Access Compliance Report

Public Rights-of-Way

(Curb Ramps)

Intersection ID: 2458	Main Street: HIGHLAND_CREEK_PY	Cross Street: MCCHESENEY_DR	Location:	N
ADA ID: 45481E0D15D7	Ramp Type: Perp	Initial Pass/Fail: Fail	Overall Compliance: No	Severity Score: 10

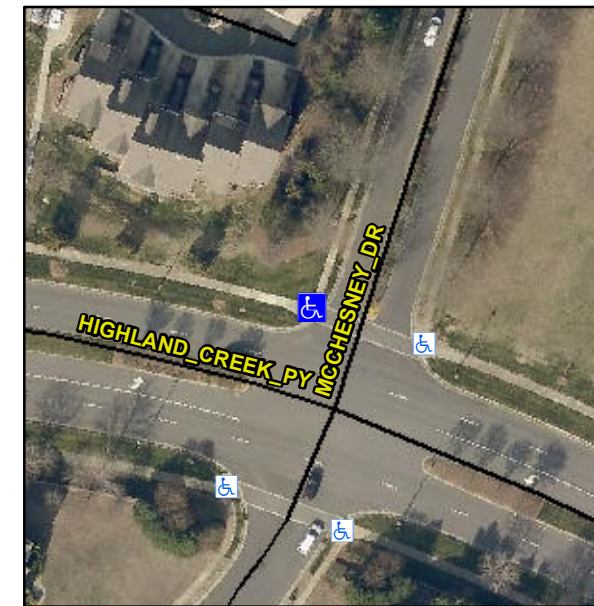
R304.5.1, R304.5.3

Compliance	Description	Data	Compliance	Description	Data
N/A	Ramp Length (in)	37.0	Yes	Ramp Slope (%)	5.2
No	Ramp Width (in)	44.0	No	Ramp XSlope (%)	4.0
N/A	Flare Type LT	N/A	N/A	Flare Type RT	N/A
N/A	Flare Slope LT (%)	N/A	N/A	Flare Slope RT (%)	N/A
N/A	Flare Traversable LT?	N/A	N/A	Flare Traversable RT?	N/A
N/A	Landing Length (in)	N/A	N/A	DWS Provided?	N/A
N/A	Landing Width (in)	N/A	N/A	DWS Contrast?	N/A
N/A	Landing Slope (%)	N/A	N/A	DWS Length (in)	N/A
N/A	Landing X Slope (%)	N/A	N/A	DWS Full Width?	N/A
N/A	Landing Curb? (Y/N)	N/A	N/A	DWS Offset (in)	N/A
N/A	Shared Landing?	N/A			
N/A	Gutter Ponding?	N/A	N/A	Gutter Slope (%)	N/A
N/A	Gutter Lip Ht (in)	N/A	N/A	Gutter X Slope (%)	N/A
N/A	Painted X Walk1?	Yes	N/A	Painted X Walk2?	N/A
	X Walk 1 Direction	To SE		X Walk 2 Direction	N/A
N/A	X Walk 1 Width (in)	97.0	N/A	X Walk 2 Width (in)	N/A
	X Walk 1 Slope (%)	1.9		X Walk 2 Slope (%)	N/A
	X Walk 1 X Slope (%)	4.9		X Walk 2 X Slope (%)	N/A

Remove & Replace Entire Ramp.
